AUGUST 2019

VICKERY EXTENSION PROJECT SUBMISSIONS REPORT

WHITEHAVEN COAL

Figure 7: Simulated Water Table (m AHD) at the End of 100 Years Recovery for the Fully Backfilled Void Scenario (Source: HydroSimulations)

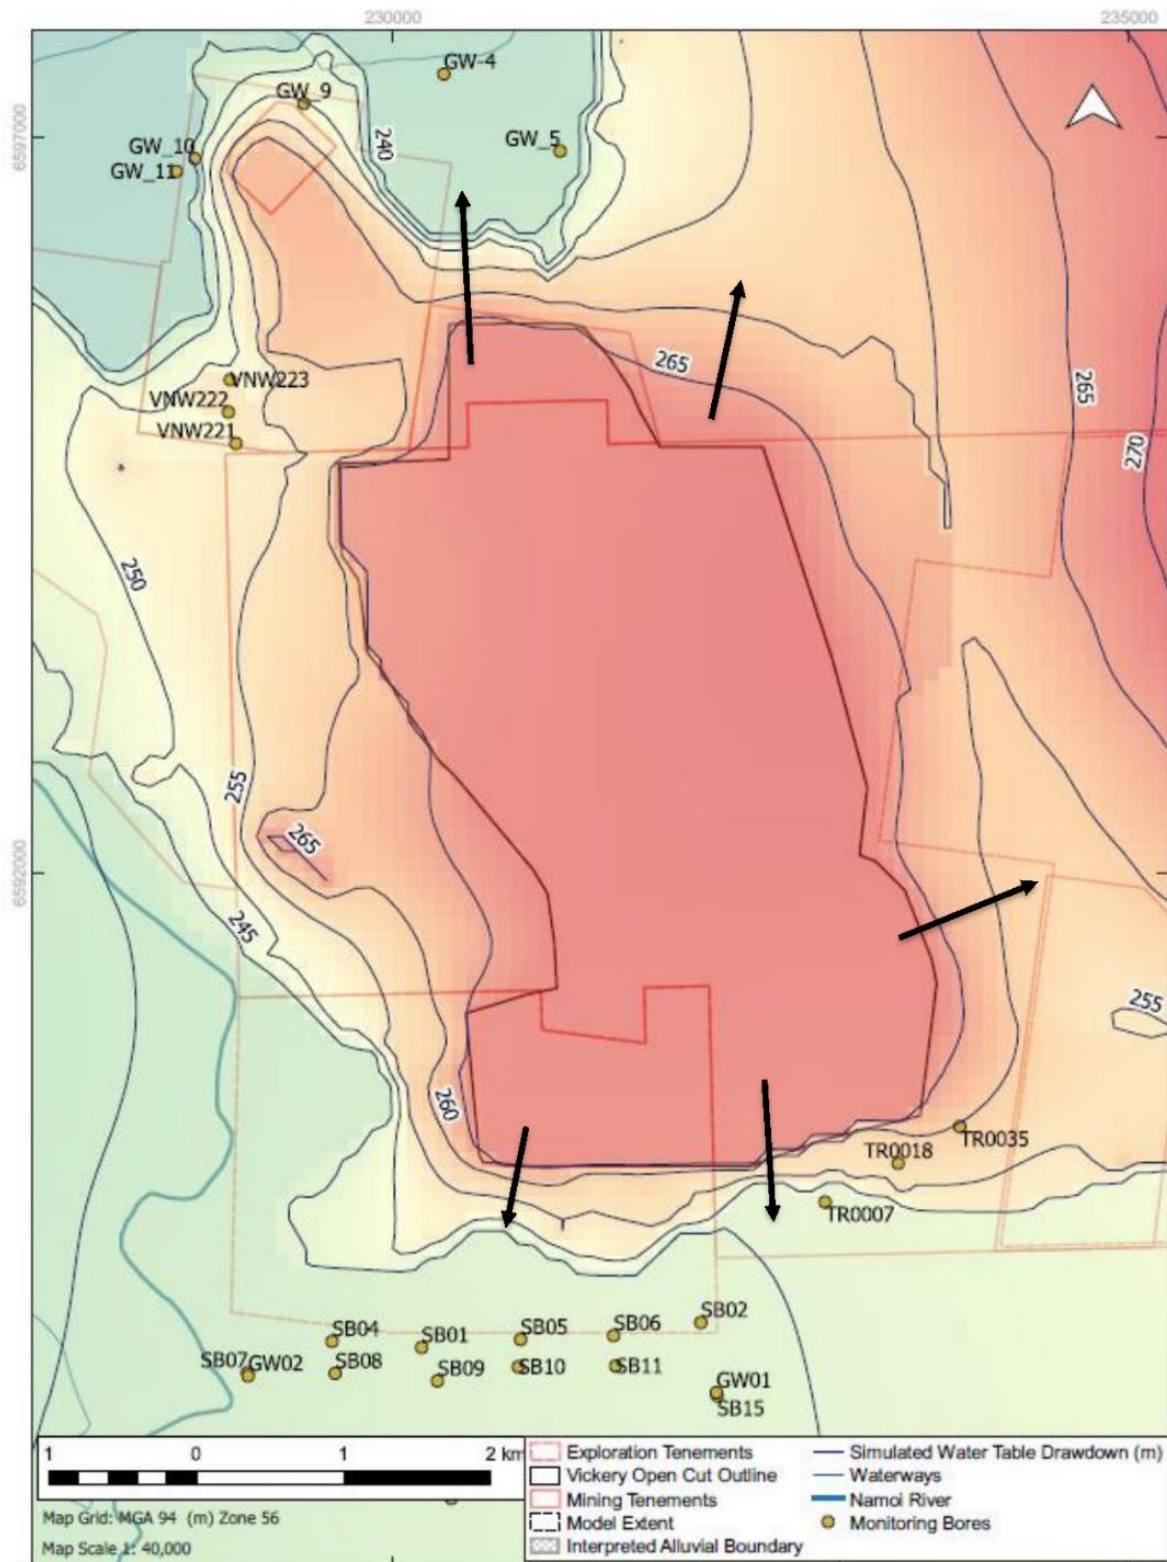
In response to the peer reviewer’s comments, HydroSimulations conducted additional groundwater modelling for a scenario where the final void is completely backfilled.

This additional modelling indicates groundwater levels within a backfilled void would recover to higher levels than the surrounding groundwater table (Figure 7). As a result, groundwater would flow from the mining area towards the surrounding Namoi River alluvium.

On this basis, it is considered this scenario (backfilled void) is environmentally inferior, as lower quality groundwater (i.e. infiltration into the backfilled void) would flow towards the Namoi River alluvium (rather than to the final void for the preferred scenario where it acts as a groundwater sink).

Figure 8a: Simulated Water Table at the End of 100 Years' Recovery (5% Rainfall Recharge of Waste Emplacement)
(Source: HydroSimulations)

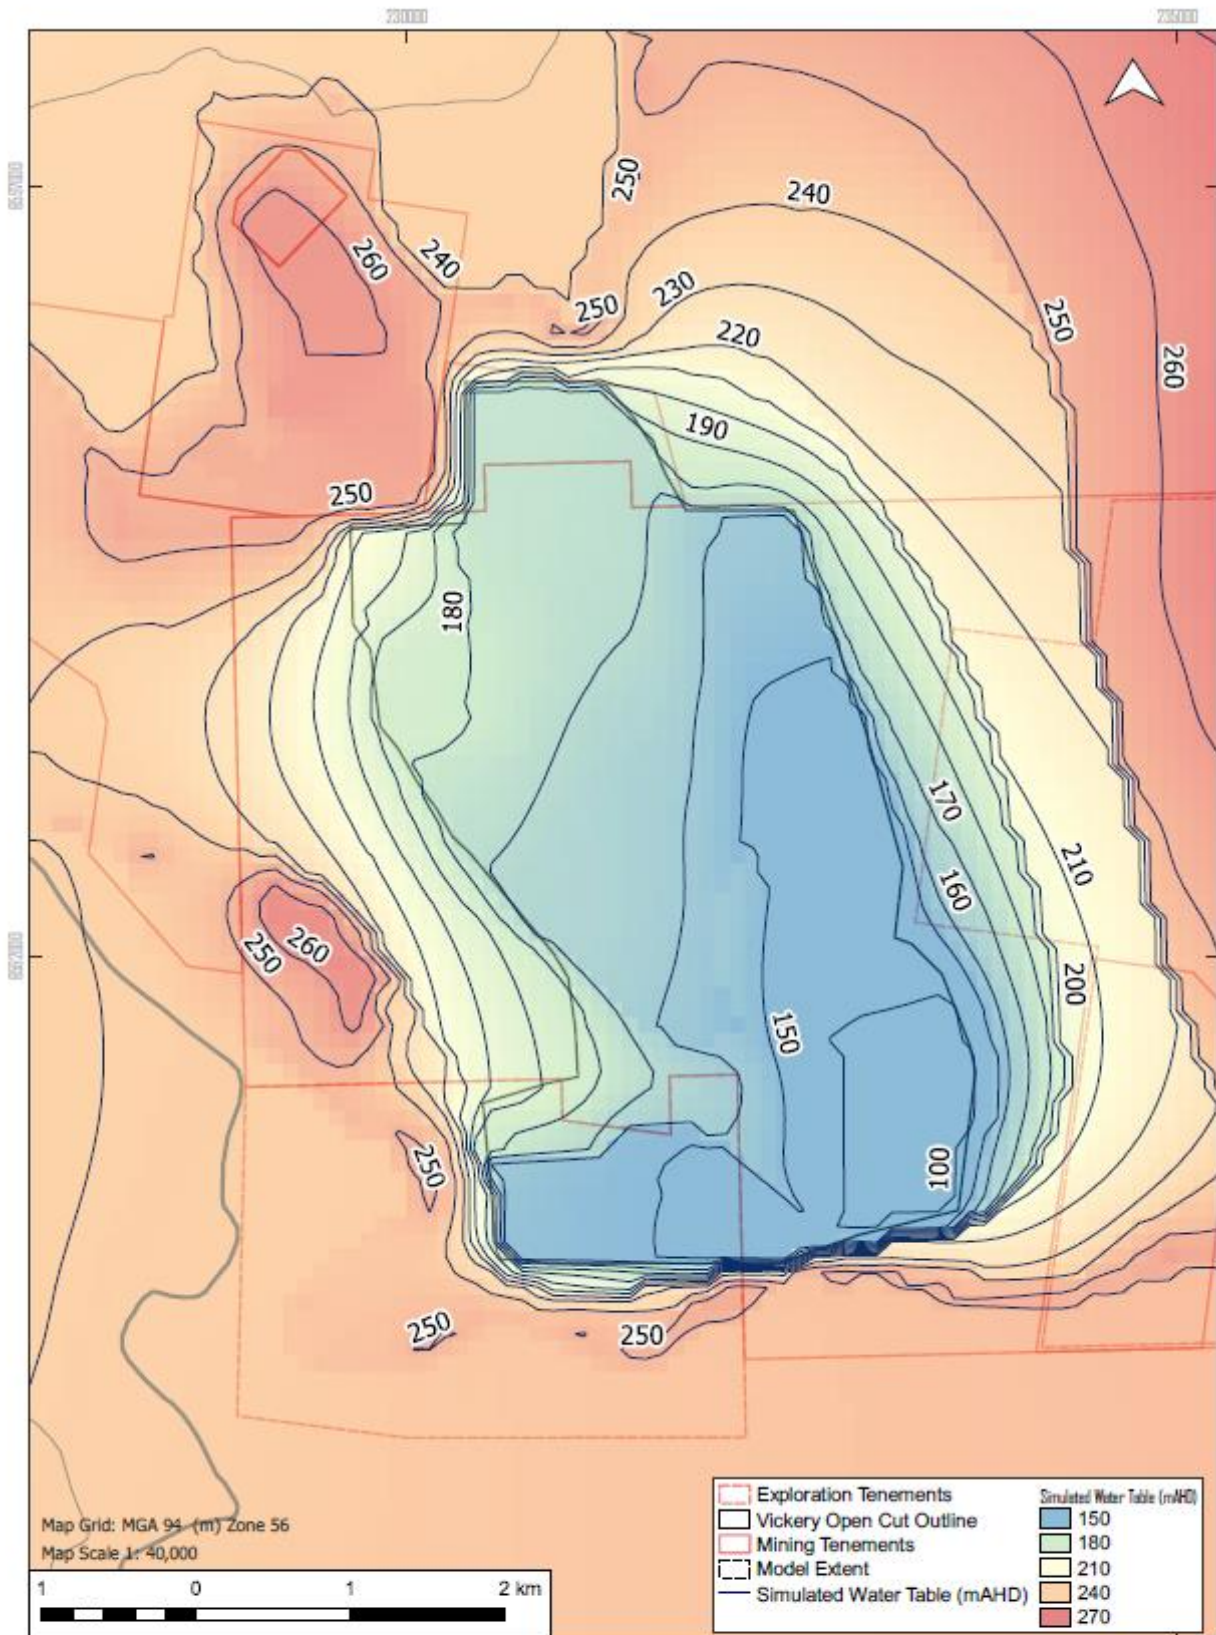
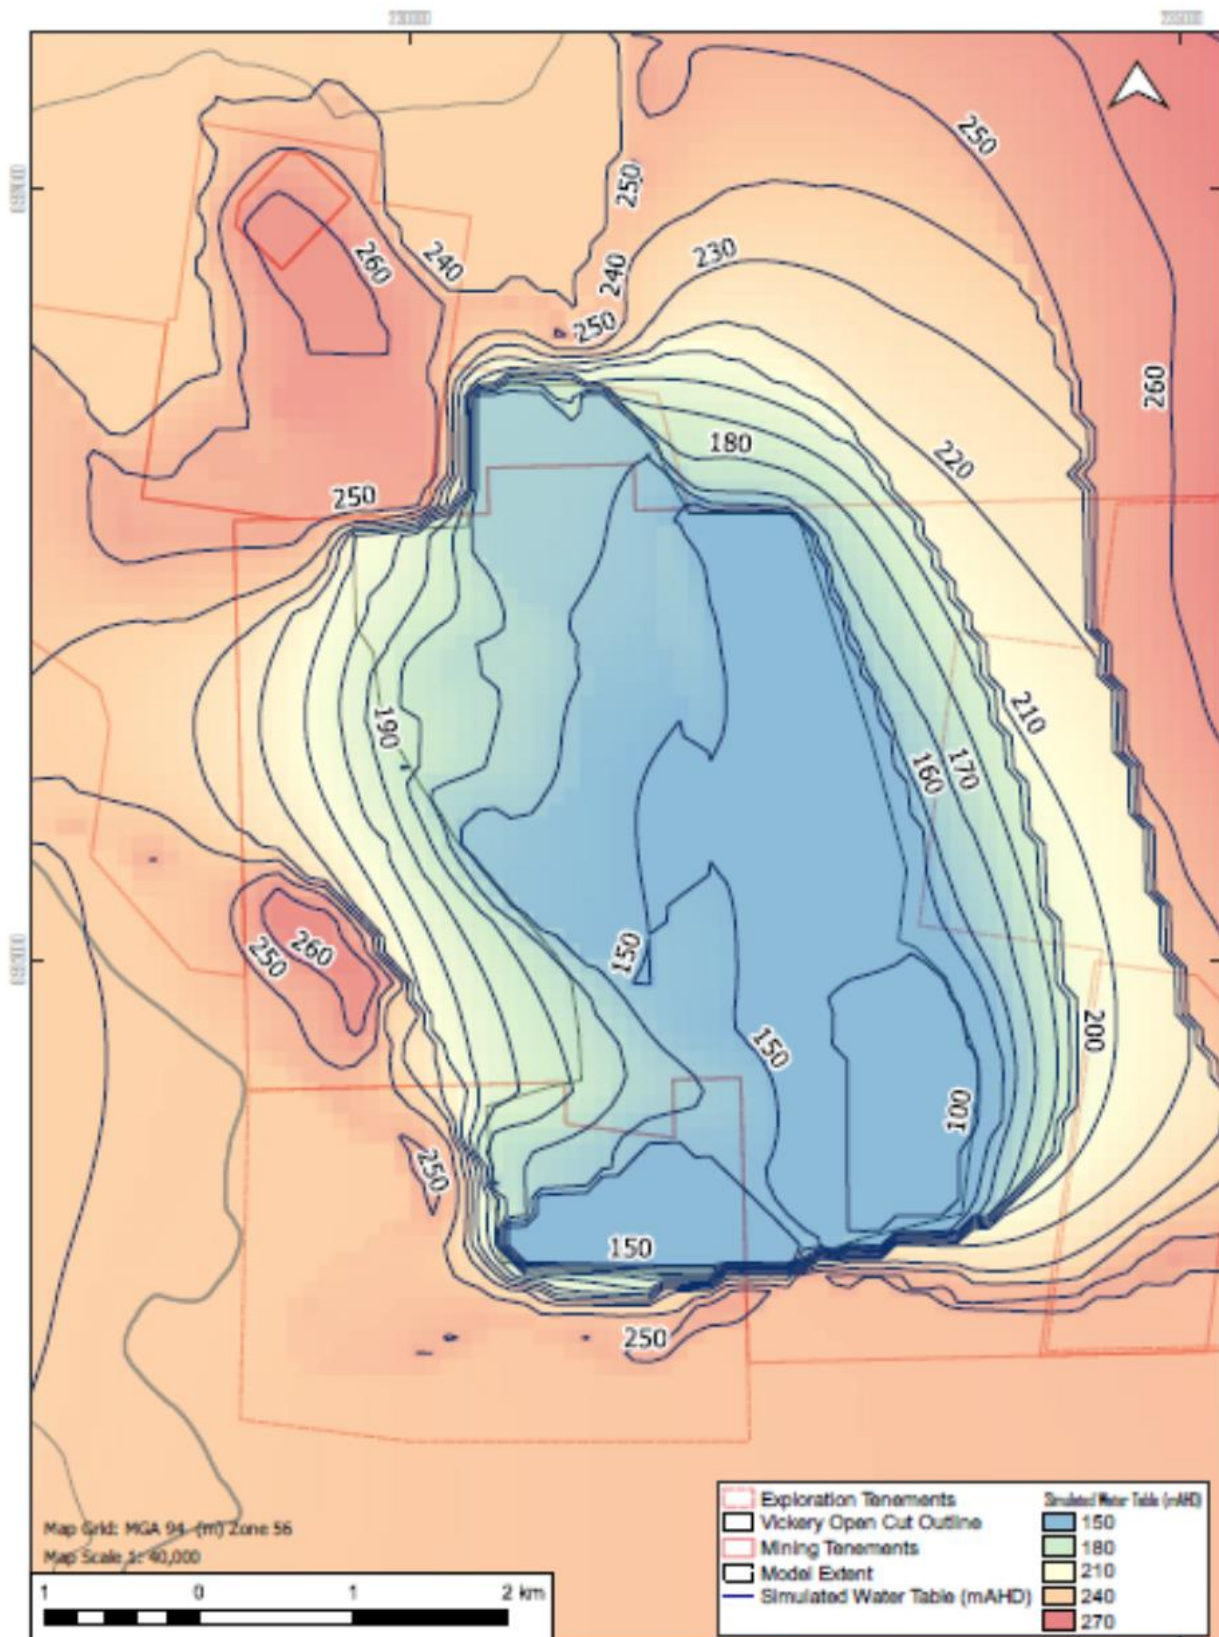
HydroSimulations has also conducted additional analysis to examine the effects of increased recharge (5% of average rainfall on the waste emplacement compared to 1% assumed for the base case modelling). The results for both scenarios show that after 100 years of recovery the final void would behave as a strong sink (Figures 8a and 8b).

Whitehaven commits to holding sufficient water licences to account for any post-mining take.

Figure 10: South Creek Riparian Zone Buffer Width

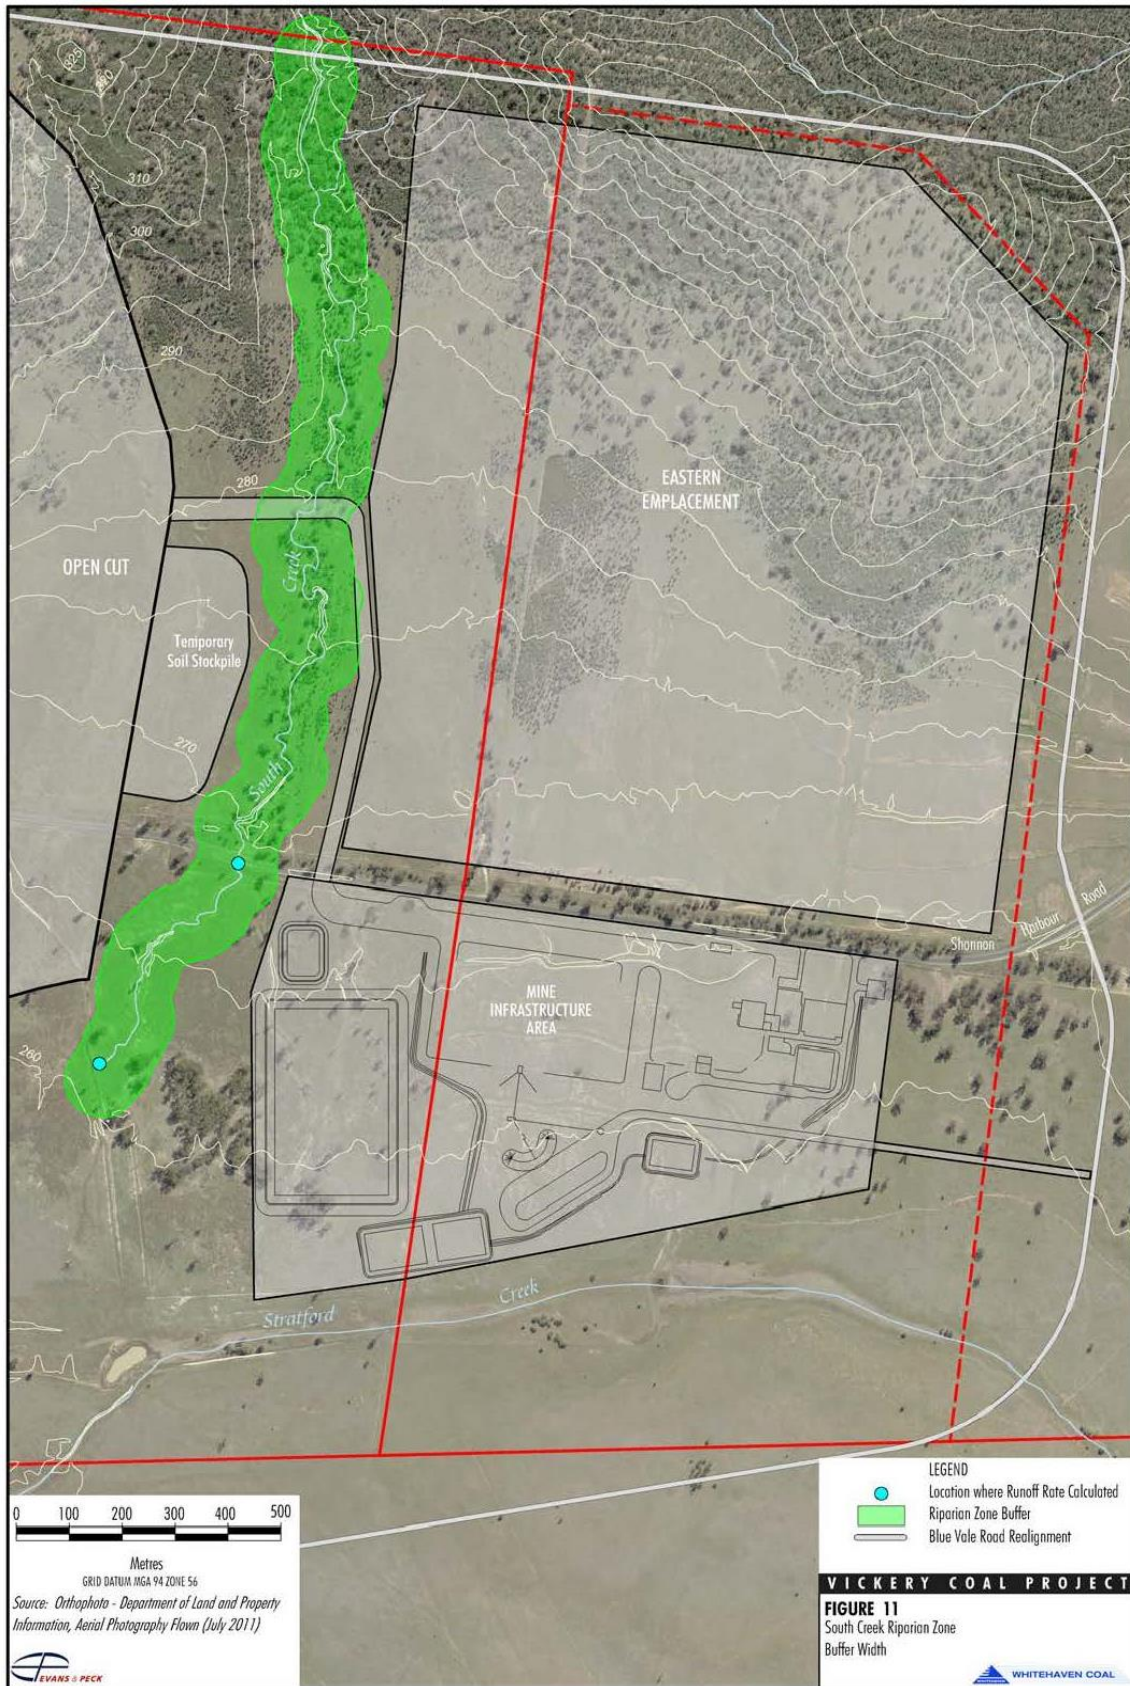
- *how the Applicant proposes to ensure that the walls of sedimentation dams and other site water storages are constructed to the appropriate standard of impermeability;*
- *the commitment of the Applicant to an appropriate water quality monitoring program for water contained in sediment basins and other mine storages. Detail of any such program should include whether it includes a full range of analytes, including those outlined in paragraph 137, that will aid in its meeting discharge standards consistently with the quality of target watercourses and, by pre-commencement monitoring, sets up appropriate trigger values for acceptable discharge;*

The secondary infrastructure area (previously the eastern emplacement for the Approved Mine) and flood protection bunds have been designed to avoid South Creek and Stratford Creek, including a 40 m vegetation buffer to minimise impacts to flooding (see Figure 11 from the Approved Mine Surface Water Assessment, provided below as Figure 10).

VICKERY EXTENSION PROJECT
Conceptual Project Rail Spur Design
(Presented in the EIS)
Predicted Flooding Impacts (1 % AEP)

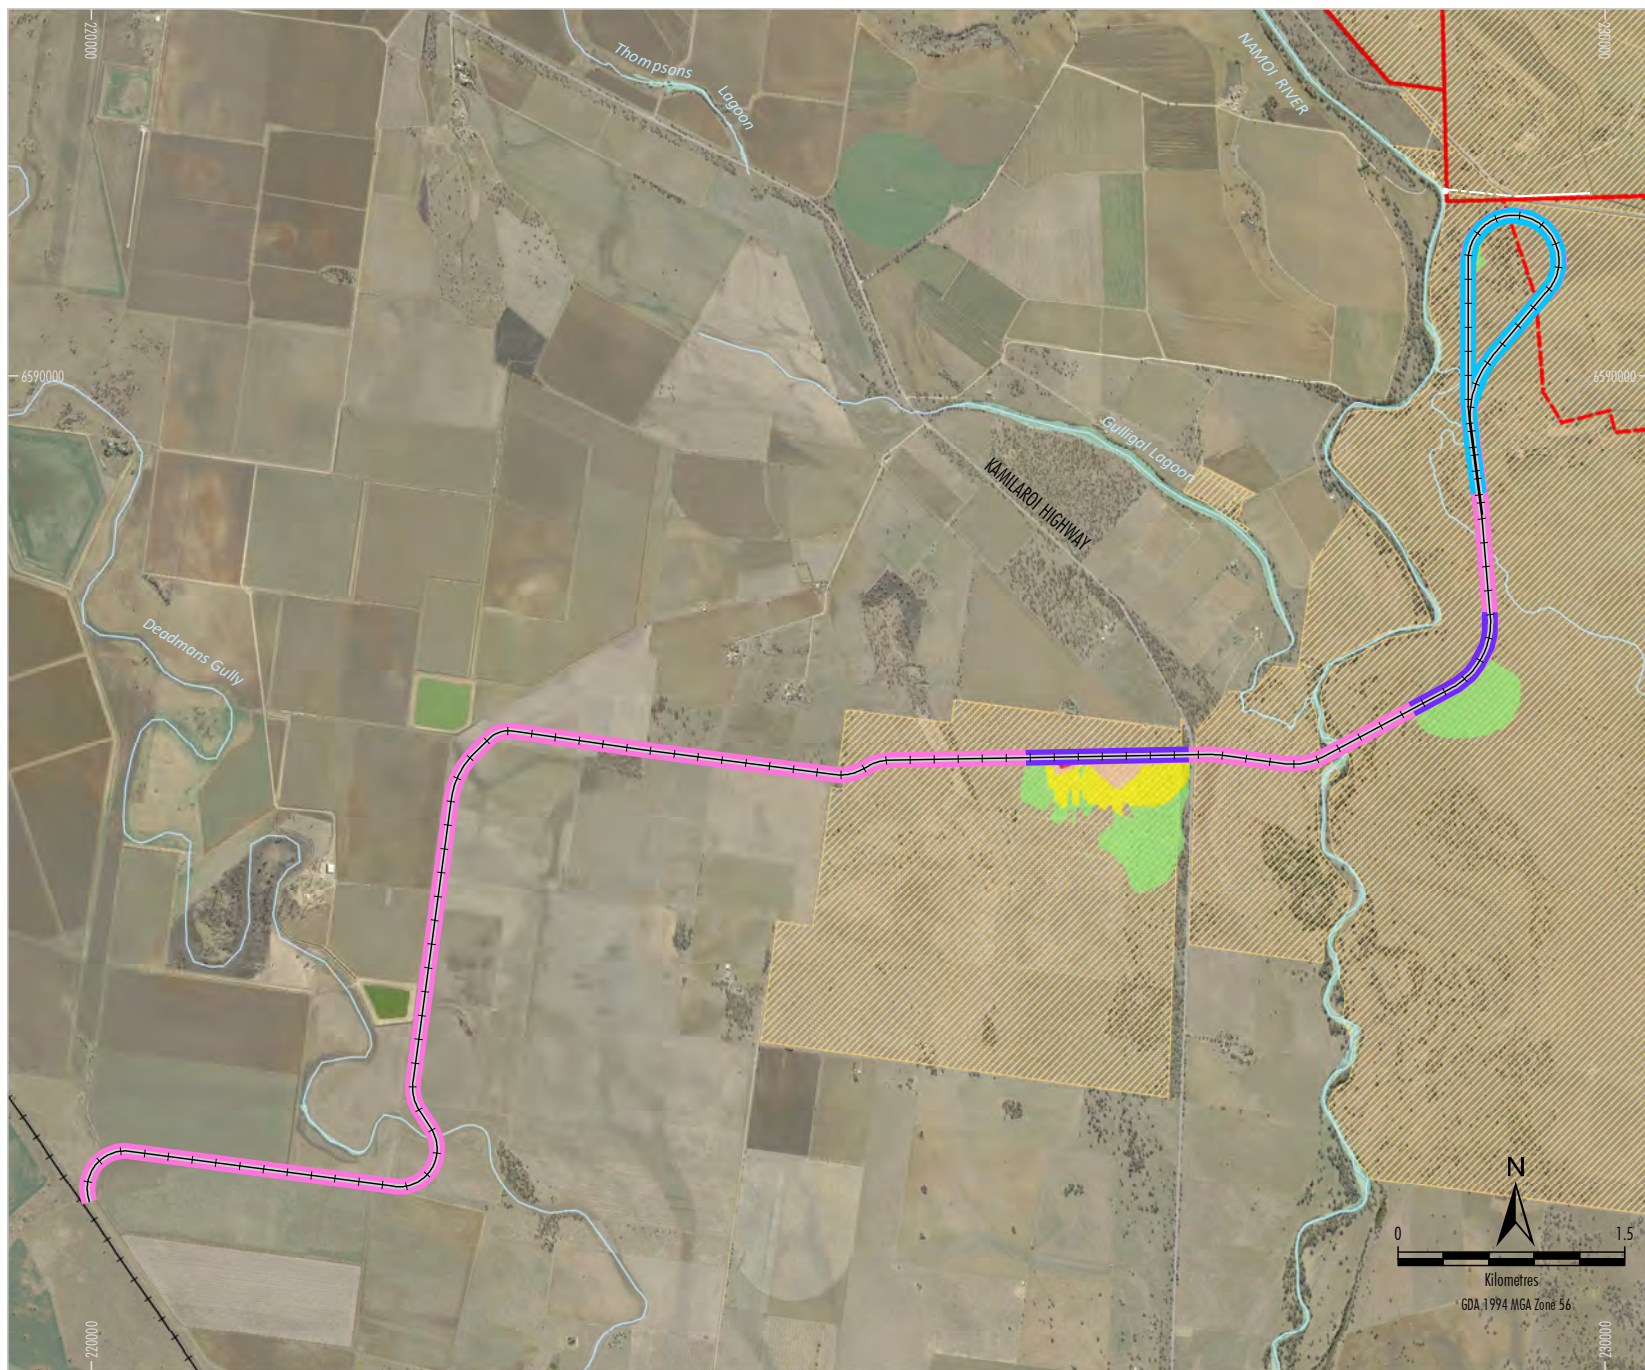
Initial conceptual design decisions involved elevating the Project rail spur above predicted flood levels (i.e. a superstructure supported on either pylon-like structures or in-filled embankment sections) and conceptually locating openings to provide for minimal impact to existing flooding regimes. Proceeding with a conceptual design involved an iterative approach during flood modelling, whereby the distribution of openings under the superstructure of the Project rail spur was adjusted to achieve consistency with the Draft FMP (Figure 11).

WRM has remodelled the Project rail spur to reflect that it will be completely elevated west of the Namoi River (Figure 12), with associated flood impact reduced in comparison to the presented in the EIS (Figure 11).
